# Access Compliance Report

## Public Rights-of-Way

Intersection ID: 11207	Main Street: GRANDIN_RD	Cross Street: W_4TH_ST	Location: S
ADA ID: F9713E3BFB57	Ramp Type: Perp	Initial Pass/Fail: Fail	Overall Compliance: No
			Severity Score: 13.75

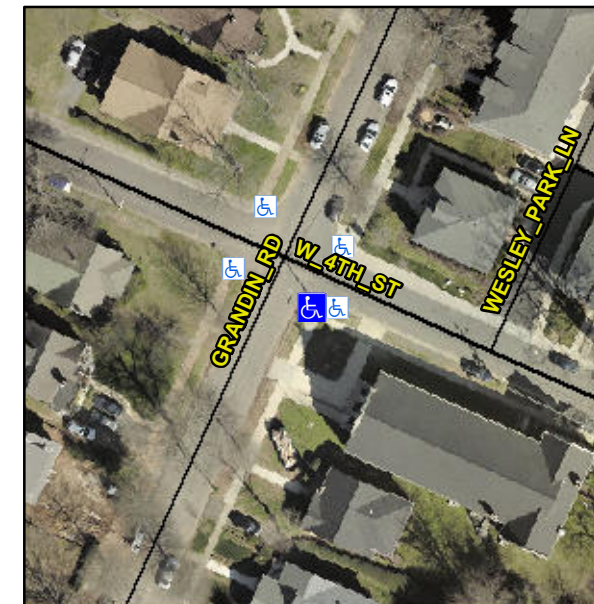
**Not Found, R304.2.2, R304.5.3**

Compliance	Description	Data	Compliance	Description	Data
N/A	Ramp Length (in)	29.0	No	Ramp Slope (%)	8.4
Yes	Ramp Width (in)	60.0	No	Ramp XSlope (%)	3.4
N/A	Flare Type LT	N/A	N/A	Flare Type RT	N/A
N/A	Flare Slope LT (%)	N/A	N/A	Flare Slope RT (%)	N/A
N/A	Flare Traversable LT?	N/A	N/A	Flare Traversable RT?	N/A
N/A	Landing Length (in)	N/A	N/A	DWS Provided?	N/A
N/A	Landing Width (in)	N/A	N/A	DWS Contrast?	N/A
N/A	Landing Slope (%)	N/A	N/A	DWS Length (in)	N/A
N/A	Landing X Slope (%)	N/A	N/A	DWS Full Width?	N/A
N/A	Landing Curb? (Y/N)	N/A	N/A	DWS Offset (in)	N/A
N/A	Shared Landing?	N/A			
N/A	Gutter Ponding?	N/A	N/A	Gutter Slope (%)	N/A
N/A	Gutter Lip Ht (in)	N/A	N/A	Gutter X Slope (%)	N/A
N/A	Painted X Walk1?	No	N/A	Painted X Walk2?	N/A
	X Walk 1 Direction	To NW		X Walk 2 Direction	N/A
N/A	X Walk 1 Width (in)	N/A	N/A	X Walk 2 Width (in)	N/A
	X Walk 1 Slope (%)	3.3		X Walk 2 Slope (%)	N/A
	X Walk 1 X Slope (%)	0.3		X Walk 2 X Slope (%)	N/A

**Remove & Replace Entire Ramp.**
